MARTIN ENERGY SERVICES-BLAKEY ISLAND **STORAGE SITE SUBDIVISION**

APPLICATION NUMBER 6 DATE September 16, 2021

REQUEST Subdivision

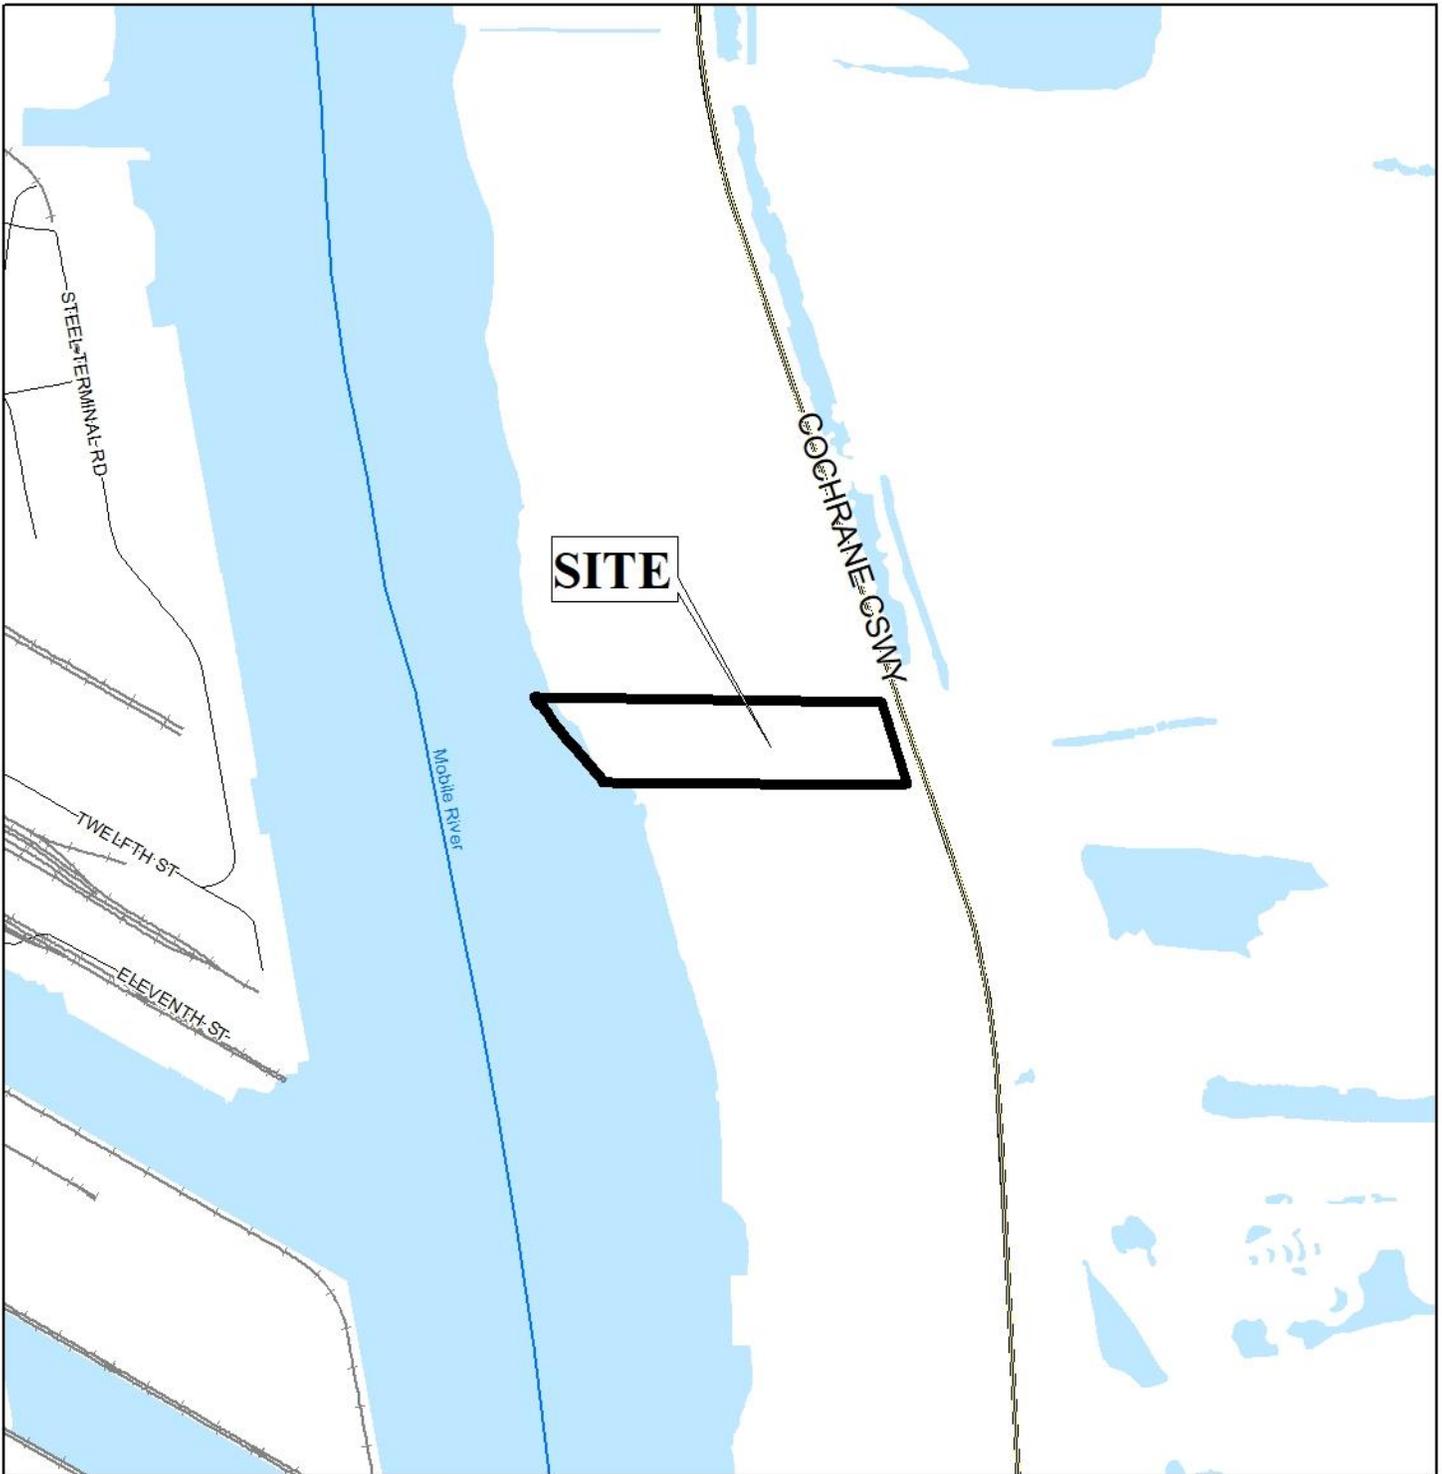
- A. Provide all of the required information on the SUBDIVISION PLAT (i.e. signature blocks, signatures, certification statements, written legal description, required notes, legend, scale, bearings and distances) that is required by the current Alabama State Board of Licensure for Professional Engineers and Land Surveyors.

- B. Label the monument set or found at each subdivision corner. Check the western property line.
- C. Show and label the north line of LOT 4 (MB3 pg. 77-78) used as the POC.

- D. Add legible street names to the vicinity map.
- E. National Wetlands Inventory (NWI) mapping, as shown on City of Mobile GIS information, indicates that there is potential for wetlands within the property or properties shown on this plat. Show and label the delineated wetlands, or provide a note stating that the wetlands shown on this plat are scaled from the NWI data and have not been delineated.

- F. Provide a note that a 25' riparian buffer may be required, during development, along the edge of anything considered by ADEM to be a water of the state. Check SURVEY NOTES #12 and #18.

- G. Update SURVEY NOTE #11. New FEMA maps went into effect on June 5, 2020.
- H. Add a note that all easements shall remain in effect until vacated through the proper Vacation process.

The preliminary plat illustrates a 25' minimum building setback line along Cochrane Causeway. If approved, the 25' setback should be retained on the Final Plat.

The preliminary plat also depicts a 30-foot easement along the front property line. Therefore, a note should be required on the Final Plat stating that no structure may be constructed or placed within any easement without the consent of the easement owner.

The proposed lot exceeds the 7,200 square foot minimum lot size requirement for a lot served by public water and sanitary sewer systems. The preliminary plat provides the lot size in square feet and acres; if approved, the lot size information should be retained on the Final Plat.

The site has frontage on Cochrane Causeway, a major street on the Major Street Plan, which should have a minimum right-of-way width of 100 feet. The site plan indicates that there is an existing right-of-way width of 120 feet, making no dedication necessary. Additionally, Cochrane Causeway (US Highway 90) is an ALDOT maintained roadway, thus as a means of access management, a note containing the Traffic Engineering comments should be placed on the Final Plat, if approved.

- 1) retention of the lot sizes in square feet and acres;
- 2) retention of the 25' minimum building setback line;
- 3) placement of a note on the Final Plat stating that no structure may be constructed or placed within any easement, without the consent of the easement owner;
